## TECHNICAL BULLETIN

TB: 20080805

**TO: Owners of SCOTT® SCBA Equipped with Heads-Up Display**  
**FROM: Rick Hofmeister**  
**SUBJECT: Addition of Anti-Rotation Clamp**  
**DATE: May 8, 2008**

**FIGURE 3 – Single Outlet Reducer Hose Clamp, SCOTT P/N 200718-01**

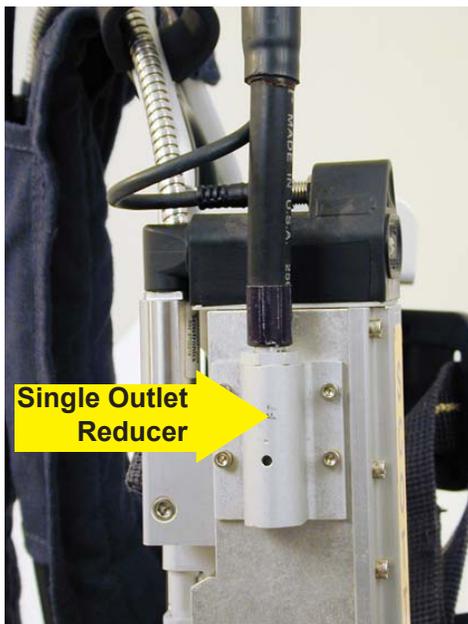
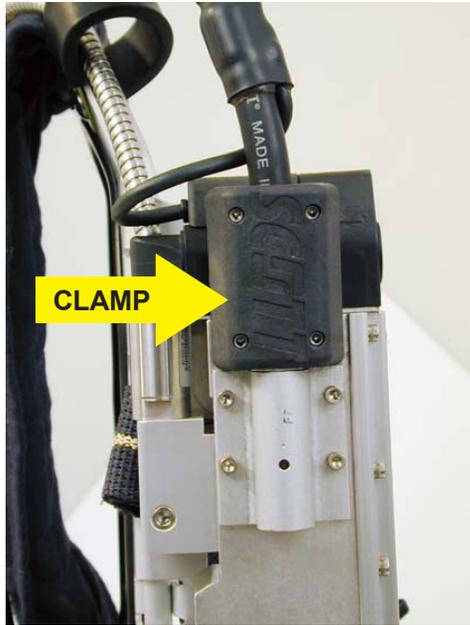
SCOTT has determined through examination of warranty returns, that the electrical connection found on the low pressure hoses used on the Air-Pak® Fifty SCBA and 2.2/3.0/4.5 Air-Pak® SCBA equipped with a Heads-up Display (HUD) may wear prematurely under heavy use conditions. SCOTT Engineers have reviewed this condition and determined that repeated rotation of the regulator and low pressure hose at the HUD connection contributes to such premature wear of the electrical connector. As a result, SCOTT is releasing an Anti-Rotation Clamp which will eliminate the repeated twisting of the low pressure hose.

Once the Anti-Rotation Clamp is installed, the movement of the low pressure hose at the electrical connection is limited eliminating stress from repeated twisting on this connection. Units that are equipped with the Anti-Rotation Clamp will appear as shown below:
